APPLICATION FOR BUILDING

Type of Project RESIDENCE-ADDITION Address 1023 E. THORNE LANE
Residence, Garage, Store, Office, School, Fence, Shed, Sign, Swimming Pool, Underground Storage Tank, Etc.

Remarks: Project - garage addition with master suite above. Interior remodel of 4 existing bathrooms.

Project Name: Bazelon Residence

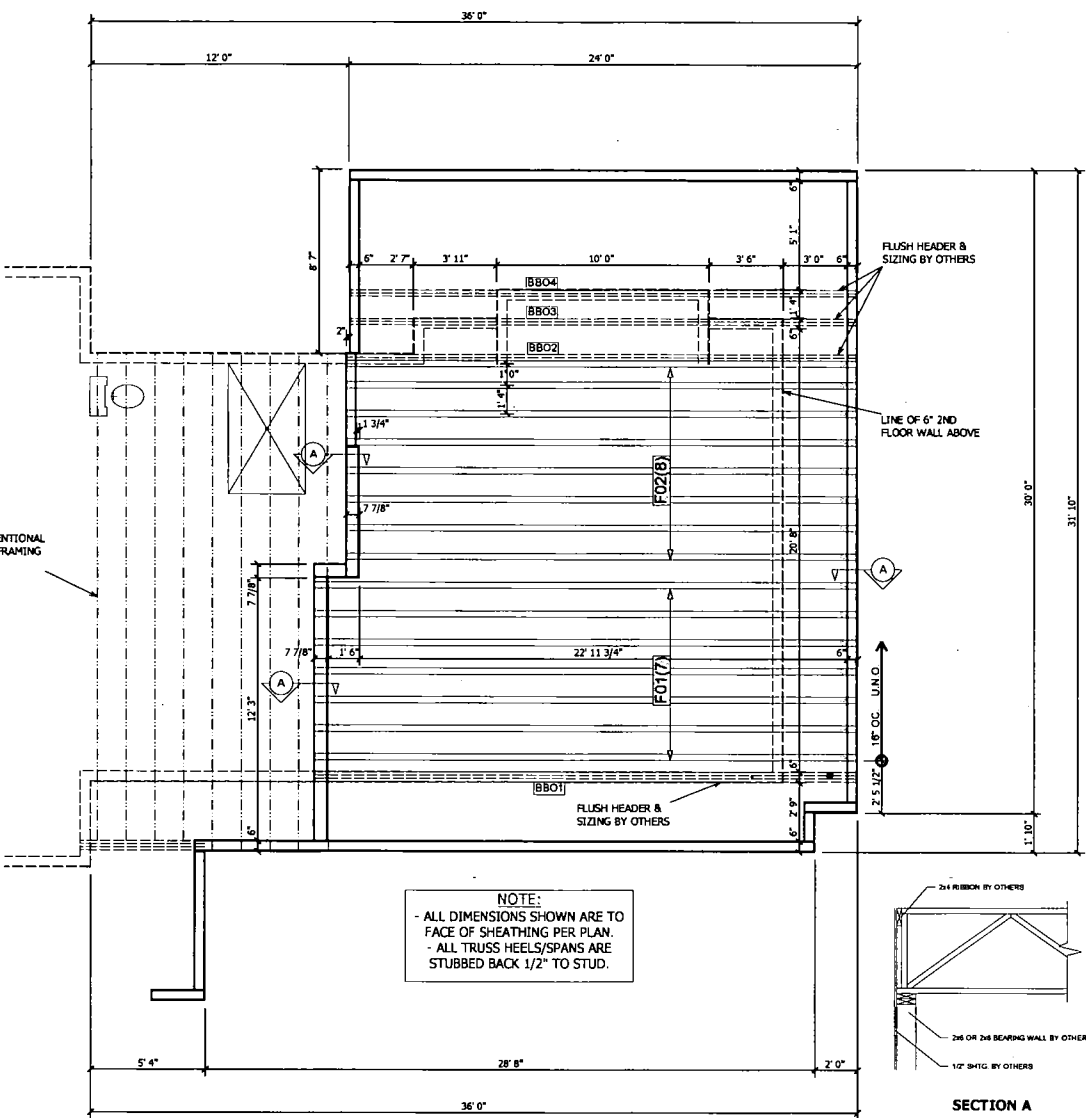
Maybe just open the ACAD drawing
The PDF files are from the Lumberyard and you may not need all of that information?

Basically, I need the following (and I already stated this on the ACAD drawing)

- Need a column specified for the garage to carry that large LVL, where the garage & house meet, with about a 20,000 pound point load
- Need a column specified in the basement to carry a different LVL that is cantilevered but still has about 3,600-4,000 pound point load
- Need the footing calc'd. for the basement column carrying the 3,600-4,000 point load

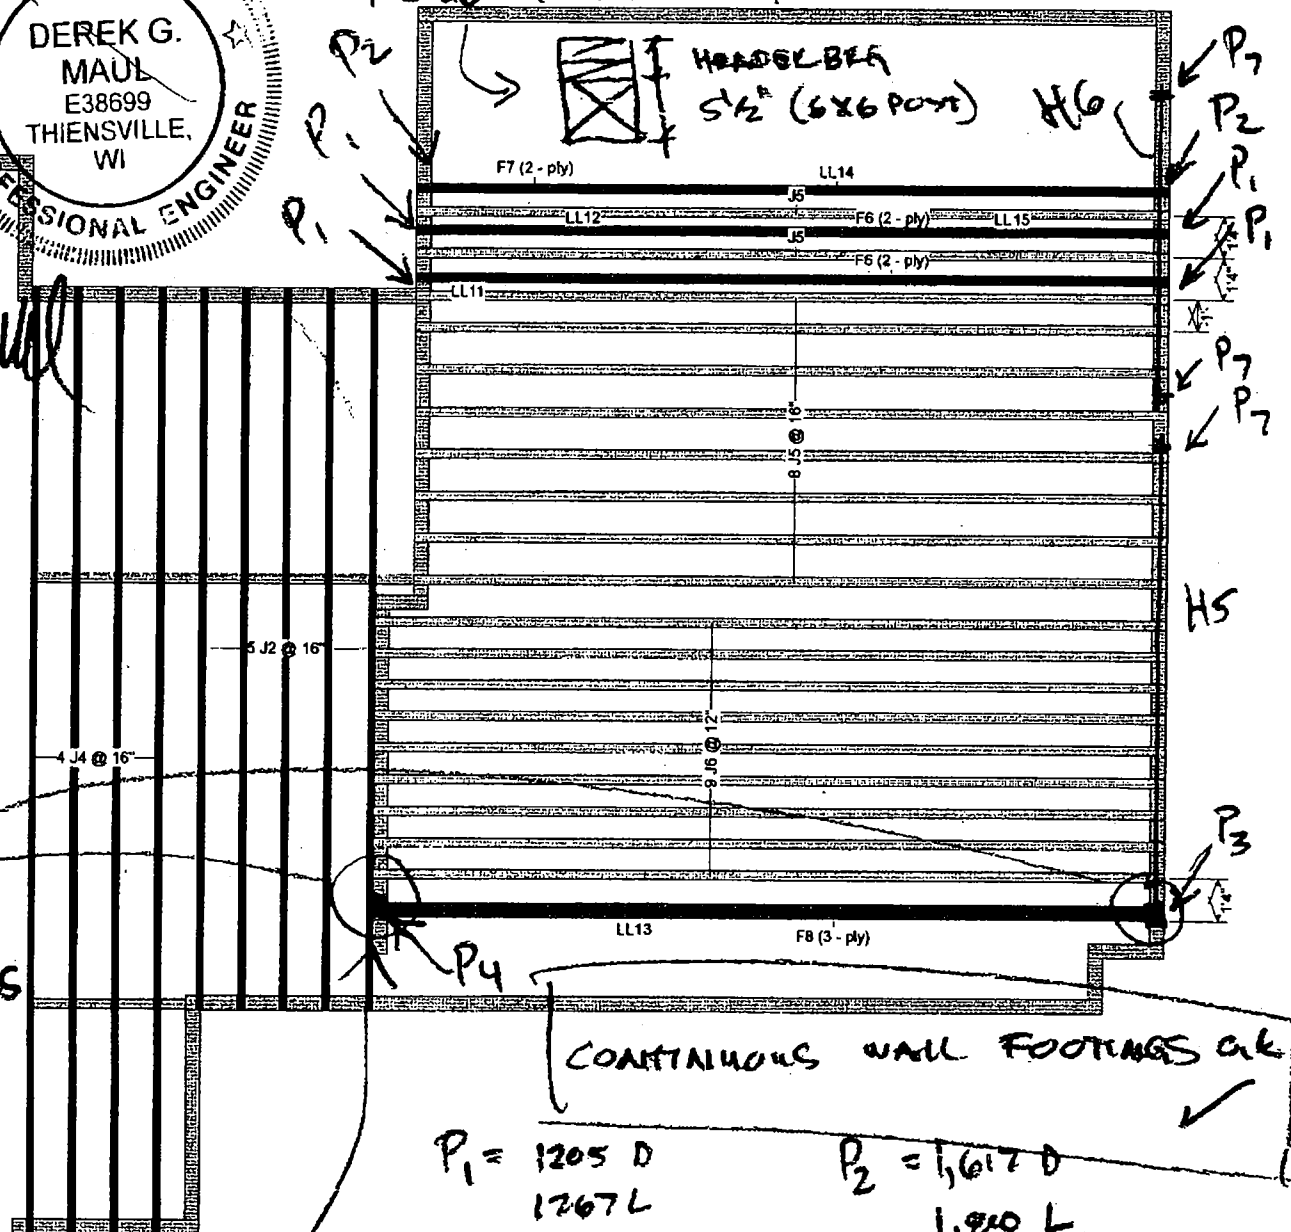
SOLID
 GROUT COLS
 BELOW P3
 & P4

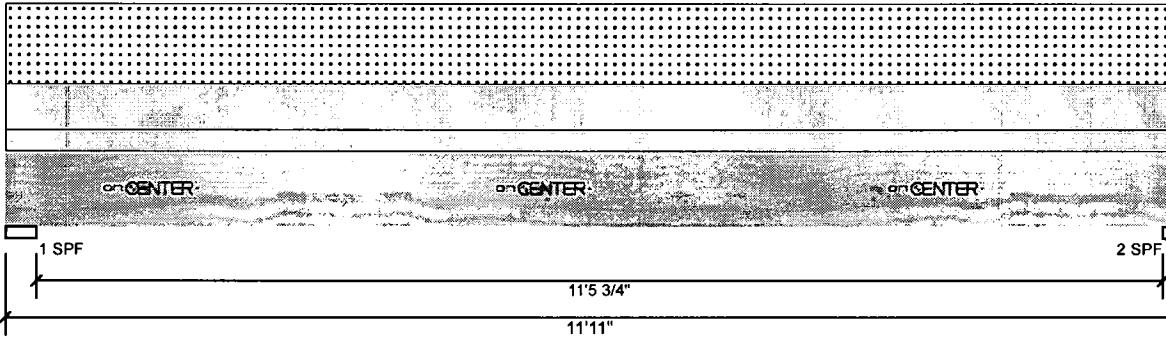
Here's what I know

- Beam clear span
 - 11'-5 ¾"
- Beam bearing on Eastern end
 - 3 ¾"
 - Original house wall is a true 2x4 so it's more than 3 ½" bearing
- Beam bearing on Western end
 - 1 ½"
- Beam size
 - Three (3) LVL's glued & screwed @ 12" c/c at top & bottom of LVL per spec
 - Outer most LVL is 12", but Eastern bearing of 3-3/4" is truly only a 9-1/2" thick beam
 - Two (2) outer most beams bear directly on the 4-ply LVL below that clear spans the garage per the design you & I composed, so the third LVL is not bearing directly on the LVL

Here is the calc that provides documentation that you can have 1-1/2" bearing on the western end of the beam. Getting the correct span length helped! For future reference, I always tell builders to have a two shoulder minimum on anything over 6' because bearing size plays a big factor in calculating beams. Fortunately, this beam doesn't have a lot to carry.
